RESPONSE TO COMMENTS - TENTATIVE REVISED WASTE DISCHARGE REQUIREMENTS FOR SUNSHINE CANYON CITY/COUNTY LANDFILL, SYLMAR, CALIFORNIA (FILE NO. 58-76)

REVISED WASTE DISCHARGE REQUIREMENT
FOR
BROWNING-FERRIS INDUSTRIES OF CALIFORNIA, INC.
(SUNSHINE CANYON CITY/COUNTY LANDFILL)

Response to Comments

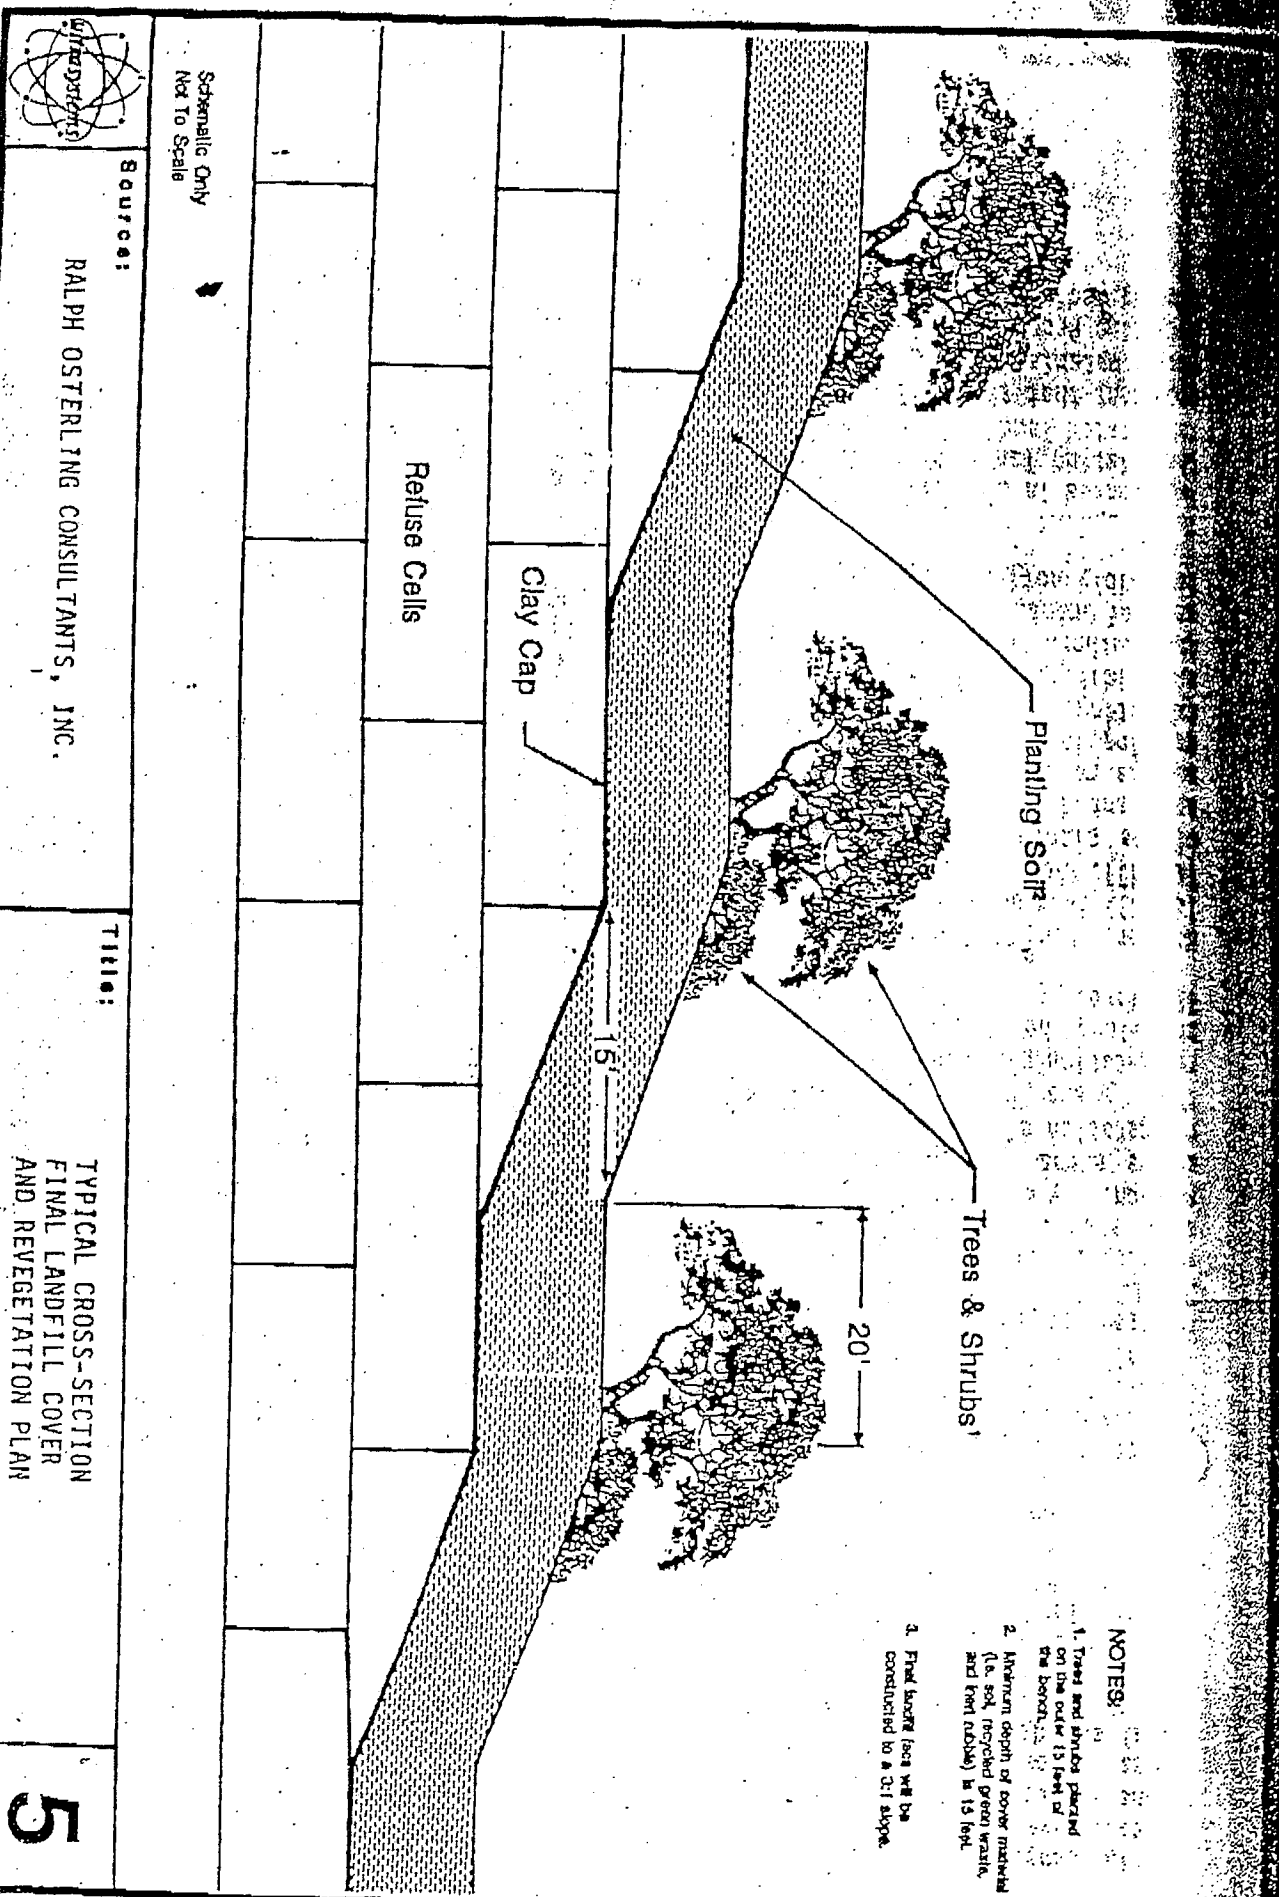
Comment: *Both the EIR and SEIR contain drawings of final covers with trees. To sustain what is described in the environmental documents as a "mosaic of trees and scrubs", there must be a final cover of soil much deeper than the 2 ft. proposed by the operator.*

From the very first approvals of Sunshine Canyon as a landfill the community was promised a final cover as described in both the EIR and the Subsequent SEIR. The attached diagram is a copy of the drawing that appears in those volumes. The wonton destruction of the closed canopy oak forest (at that time the densest in the County) was an environmental tragedy. To sustain what is described in the environmental documents as a "mosaic of trees and scrubs" there must be a final cover of soil much deeper than the 2 ft. requested by the operator. I know that it is much cheaper to throw wild grasses over the trash, but this is a clear betrayal of those who have waited 50 years for any portion of the landfill to be properly closed.

Response: State and Federal regulations require that landfill final cover must be designed to minimize infiltration and erosion. The final cover system that BFI proposed in the JTD meets the requirements included in Section 21090 of 27 CCR for Class III landfill final cover systems. The Regional Board may approve alternative final cover systems, such as the five-foot thick monolithic final cover that has been constructed on top of the closed City Landfill Unit 1. However, large trees, such as oak, are not suitable to be planted on the final cover because, with their deep root system, they may damage the integrity of the final cover and cause maintenance problems.

SLOPE COVER SECTION

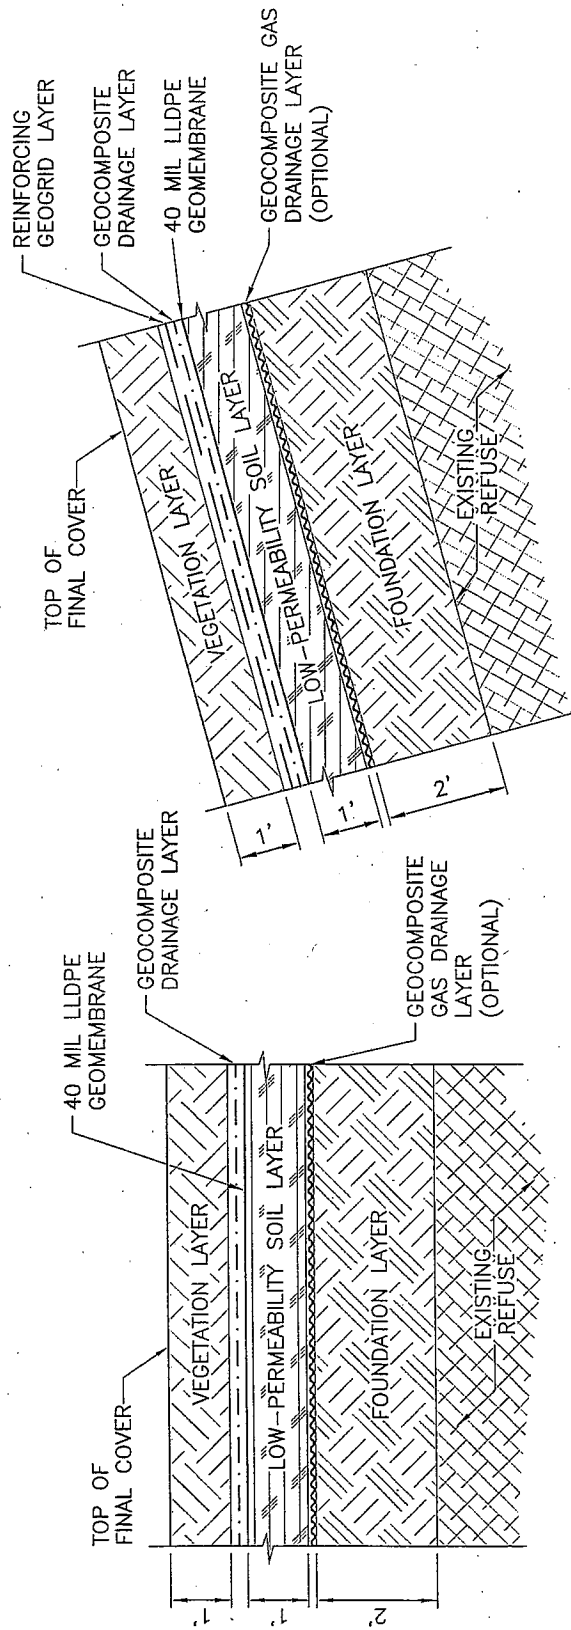
Comment: *Replace Figure 5 of the tentative WDRs and Figure T-2 of the tentative Monitoring and Reporting Program with updated figures.*

In addition, Figure 5 referenced in this paragraph should be replaced with the Final Cover Section figure attached herewith, which is from the Joint Technical Document (JTD).

Response: Those two figures have been replaced with new figures provided by BFI.
